## ADMINISTRATIVE SITE DEVELOPMENT PLAN REPORT & DECISION

**REPORT DATE:** September 23, 2014

**Project Name:** Hotel at Soutport

**File Number:** LUA14-000645, SA-A, SM, MOD, MOD

EXHIBIT 23

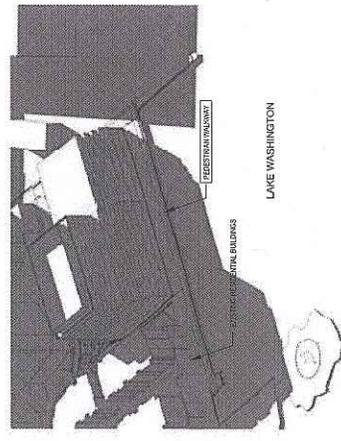
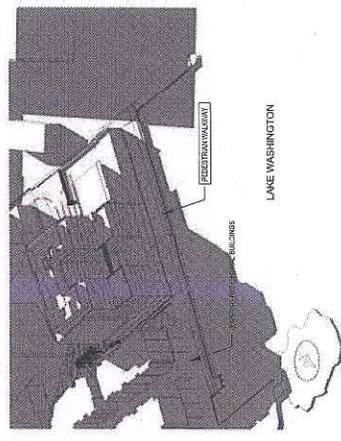
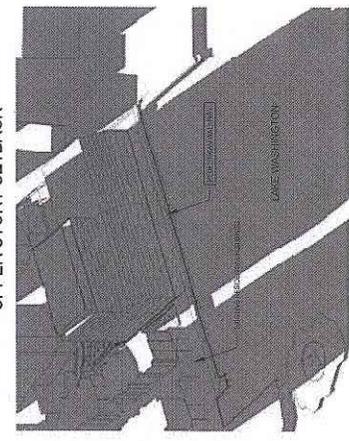
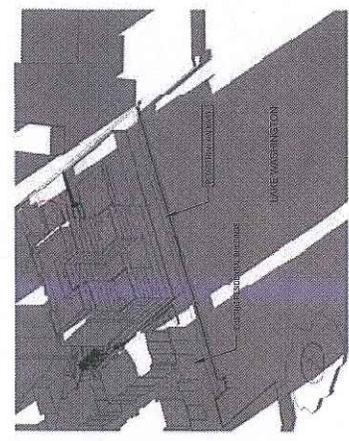
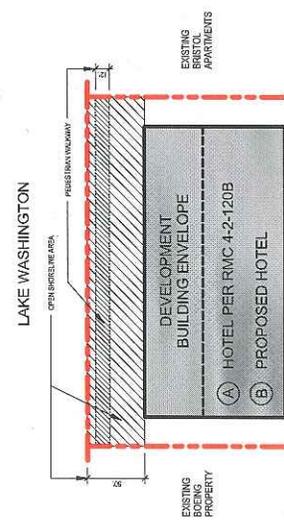
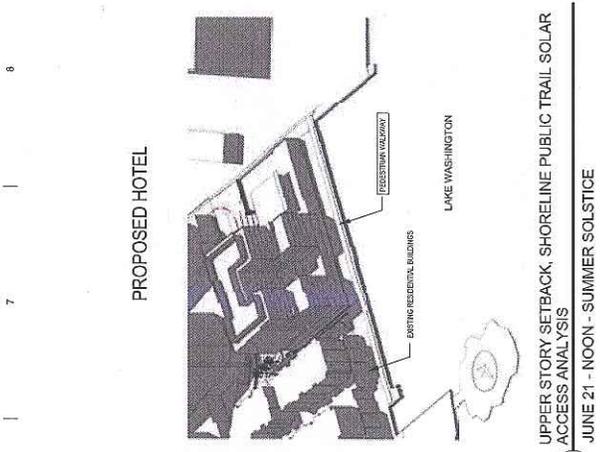
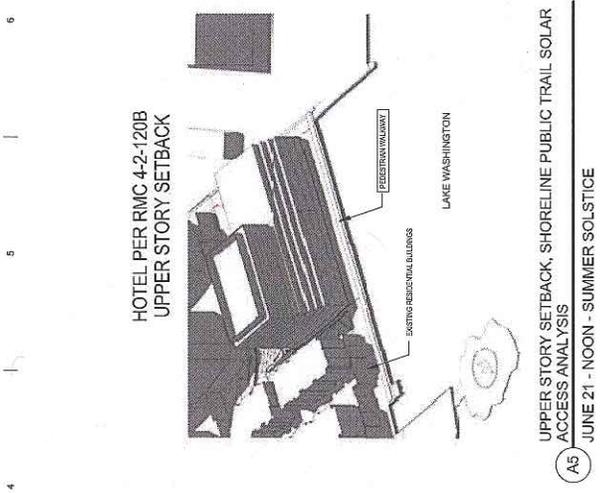
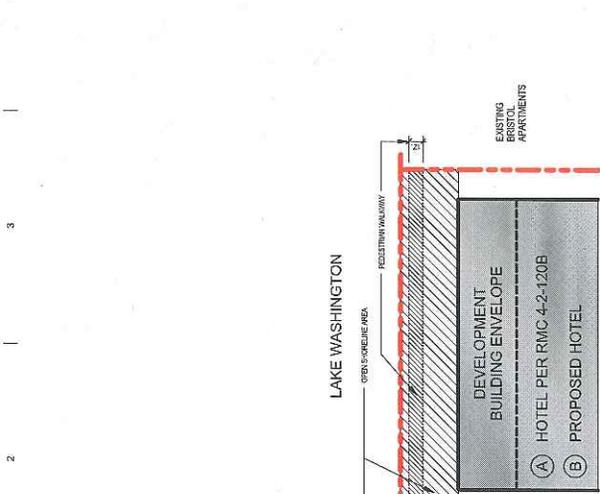
✓	<p><b>Upper Story Setbacks:</b> Per RMC4-2-120 Buildings or portions of buildings which exceed 50-feet in height which are located within 100 feet of the shoreline shall include upper story setbacks for the façade facing the shoreline and for facades facing publicly accessible plazas as follows: The minimum setback for a fifth story and succeeding stories shall be 10 feet. Projects not meeting the upper story setbacks may be approved through a modification process. Application may be made for modification of the upper story setback standards when superior design is demonstrated pursuant to RMC 4-9-250D. For a modification to be granted, the project must also comply with the decisions and design criteria stipulated in RMC 4-9-250D2 and D4.</p> <p><u>Staff Comment:</u> <i>The applicant contends that the proposed hotel offers a superior design solution as an alternative to the upper story setback requirement. Pursuant to RMC 4-9-250D the applicant has requested a modification to the upper story setbacks requirement found in RMC 4-2-120B.</i></p> <p><i>Section 4-9-250 allows a grant of relief from the requirements of the code which permits construction in a manner that otherwise is prohibited, provided the modification meets the following criteria:</i></p> <ul style="list-style-type: none"><li><i>a. Will meet the objectives and safety, function, appearance, environmental protection and maintainability intended by the Code requirements, based upon sound engineering judgment; and</i></li><li><i>b. Will not be injurious to other property(ies) in the vicinity; and</i></li><li><i>c. Conform to the intent and purpose of the Code; and</i></li><li><i>d. Can be shown to be justified and required for the use and situation intended; and</i></li><li><i>e. Will not create adverse impacts to other property(ies) in the vicinity; and</i></li><li><i>f. In comparison to the standard upper story setbacks, the proposed building design will achieve the same or better results in terms of solar access to the public shoreline trails/open space and publicly accessible plazas; the building will allow access to sunlight along the public trail/open space system and plazas abutting</i></li></ul>
